Item ID: D350-689-023 Accept ***N900040100*** Setup Start ***NS1***
 Revision ID: Stop ***NS2***
 Item Name: Floor Provisions - Energy Attenuating Seat Compatible
 Start Date: 4/23/14 Start Qty: 1.00 ***1*** Cust Item ID:
 Required Date: 4/23/14 Req'd Qty: 1.00 ***1*** Customer:
 Reference:

DART SERVICE INSTRUCTION

TO AMEND INSTALLATION INSTRUCTIONS IIN-D350-689 REV. B AND INSTRUCTIONS FOR CONTINUED AIRWORTHINESS ICA-D350-689 REV. 1

FIGURE 1: UPDATES TO CROSS SECTIONS F-F AND M-M
 With reference to Figures 5 and 7 of IIN-D350-689
 (Figures 25-5 and 25-7 of ICA-D350-689)

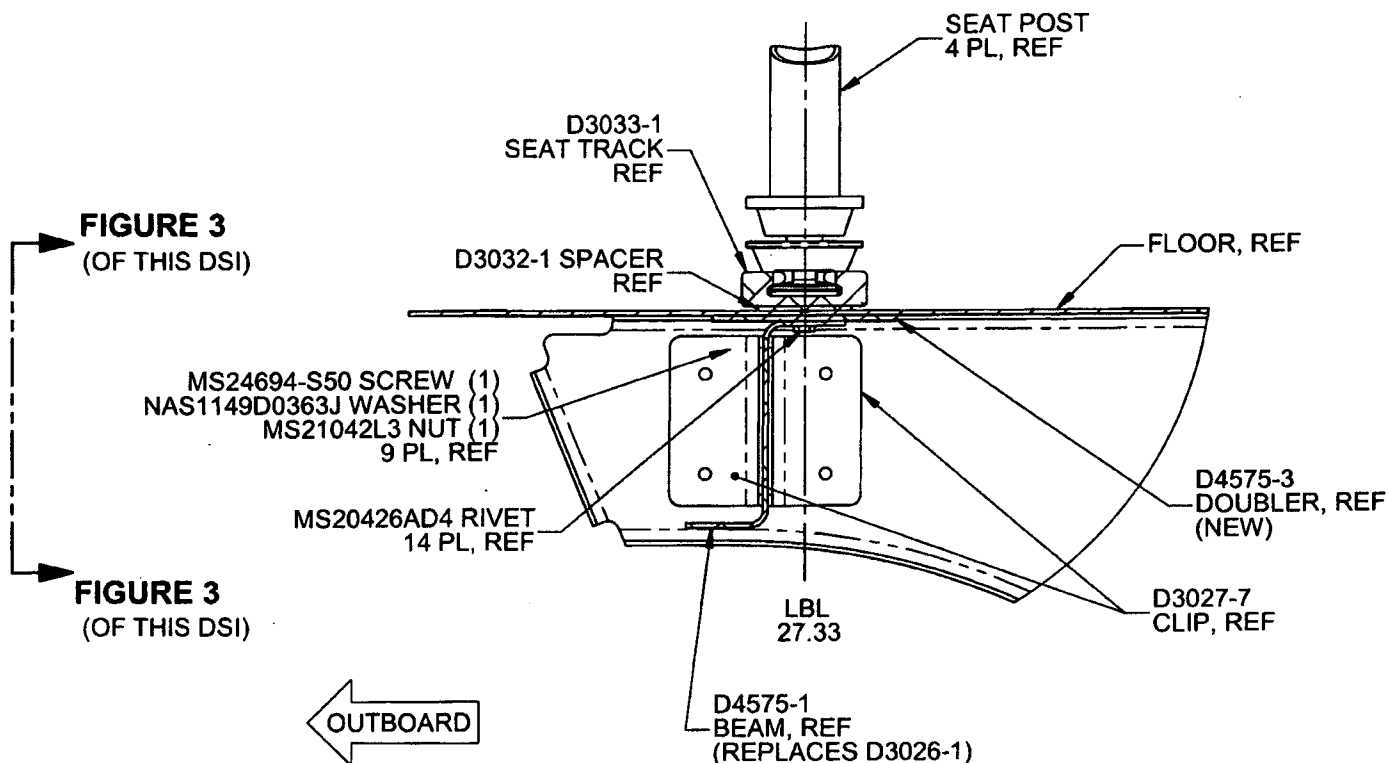
If there is an existing stringer at LBL 27.33, it will need to be removed from that location. Locate D4575-1 Beam, D4575-3 Doubler, and D3032-1 Spacer as shown in Figure 1 of this Service Instruction. Transfer drill existing holes from the aircraft floor to the D4575-1 Beam, D4575-3 Doubler, and D3032-1 Spacer. Ensure 1.0" to 1.5" rivet pitch and add additional holes if required. If there is no existing stringer, locate D4575-1 Beam, D4575-3 Doubler, and D3032-1 Spacer as shown in Figure 1 of this Service Instruction and drill Ø0.128" holes on a 1.0" to 1.5" pitch.

If there is an existing stringer at LBL 27.33, it will need to be removed from that location. Locate D4575-1 Beam and D4575-3 Doubler as shown in Figure 2 of this Service Instruction. Transfer drill existing holes from the aircraft floor to the D4575-1 Beam and D4575-3 Doubler. Ensure 1.0" to 1.5" rivet pitch and add additional holes if required. If there is no existing stringer, locate D4575-1 Beam and D4575-3 Doubler as shown in Figure 1 of this Service Instruction and drill Ø0.128" holes on a 1.0" to 1.5" pitch.

FIGURE 3: RELIEFS ON D4575-1/-3
(ONLY D4575-1/-3 SHOWN FOR CLARITY)
VIEW LOOKING INBOARD

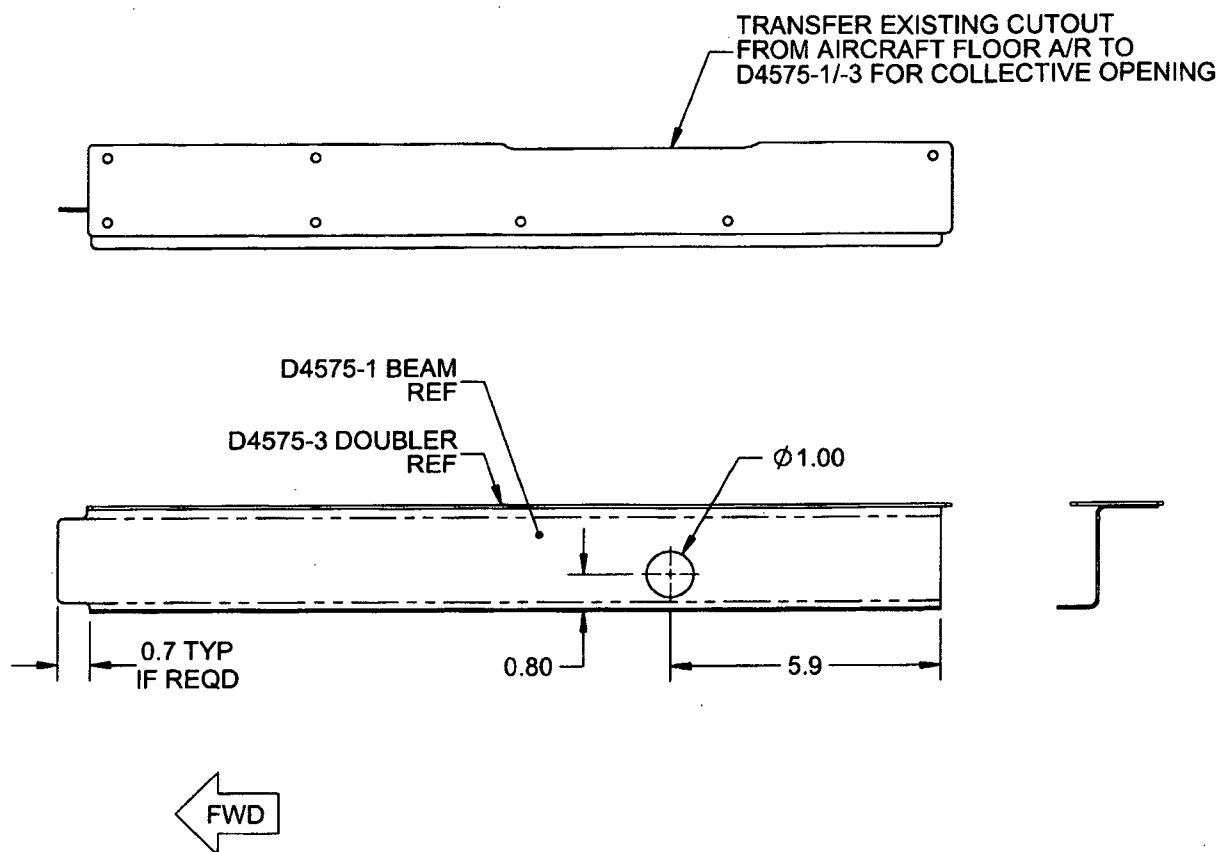
Note: Drill a Ø1.00" (Ø25.4 mm) hole in the D4575-1 Beam to clear extension tube of collective and cutout as required for clearance of collective opening and fwd bulkhead as shown in Figure 3 of this Service Instruction.

Note: Drill a Ø1.00" (Ø25.4 mm) hole in the D4575-1 Beam to clear extension tube of collective and cutout as required for clearance of collective opening and fwd bulkhead as shown in Figure 3 of this Service Instruction.
